UNITED STATES
NUCLEAR REGULATORY COMMISSION
WASHINGTON, D.C. 20555-0001

SUBJECT: BRAIDWOOD STATION, UNITS 1 AND 2, AND BYRON STATION, UNIT NOS. 1 AND 2 - ISSUANCE OF AMENDMENTS RE: CLARIFICATION OF OPERATING LICENSE AND TECHNICAL SPECIFICATIONS (TAC NOS. MD9360, MD9361, MD9362, AND MD9363)

1. Amendment No.160 to NPF-72
2. Amendment No.160 to NPF-77
3. Amendment No.165 to NPF-37
4. Amendment No.165 to NPF-66
5. Safety Evaluation

Figure 3.7.16-1 (page 1 of 1)
Region 2 Fuel Assembly Burnup Requirements

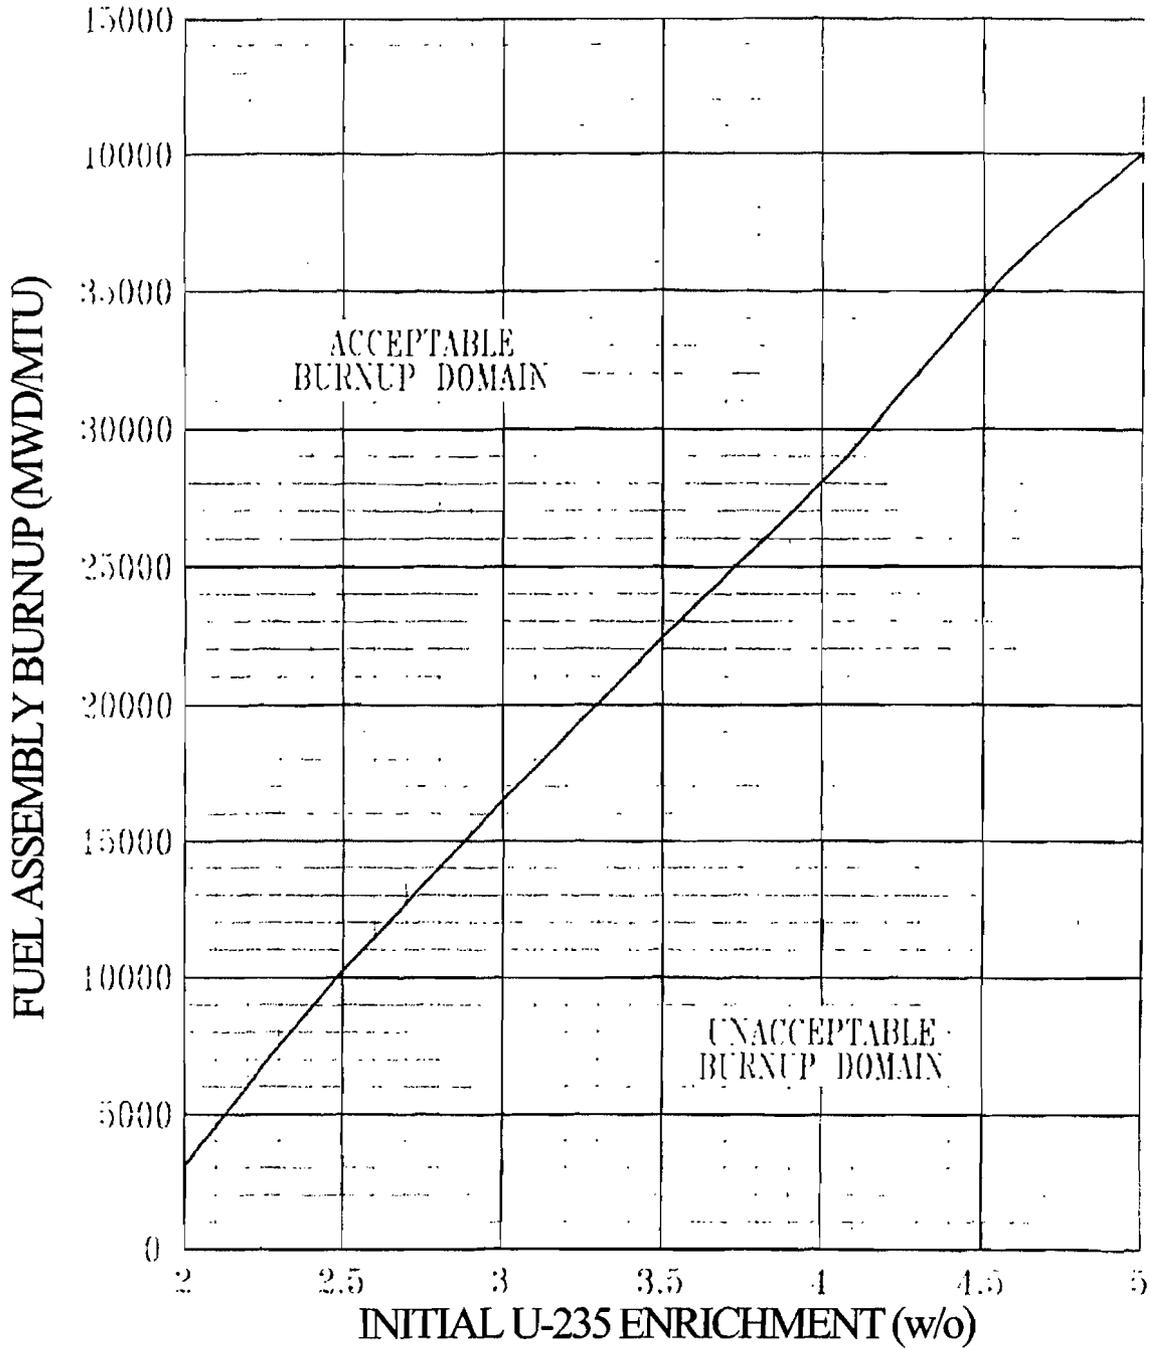
Revise TS 3.7.15, "Spent Fuel Pool Boron Concentration," TS 3.7.16, "Spent Fuel Assembly Storage," and TS 4.3.1, "Criticality," to remove all references to Joseph Oat spent fuel pool storage racks, including the deletion of existing Figures 3.7.16-1, 3.7.16-2, and 3.7.16-3, the renumbering of existing Figure 3.7.16-4 to 3.7.16-1, and required formatting changes. As stated in the LAR, the Joseph Oat spent fuel storage racks have been replaced with Holtec spent fuel storage racks as of January 1, 2001. (The licensee noted in the LAR that similar changes were not proposed for Braidwood because the Braidwood Station TS were previously revised to remove references to Joseph Oat fuel storage racks in Braidwood License Amendment No. 145 (ADAMS Accession No. ML072620362)). The NRC staff finds that, because the Joseph Oat spent fuel storage racks are no longer installed at Byron, the removal of references to these
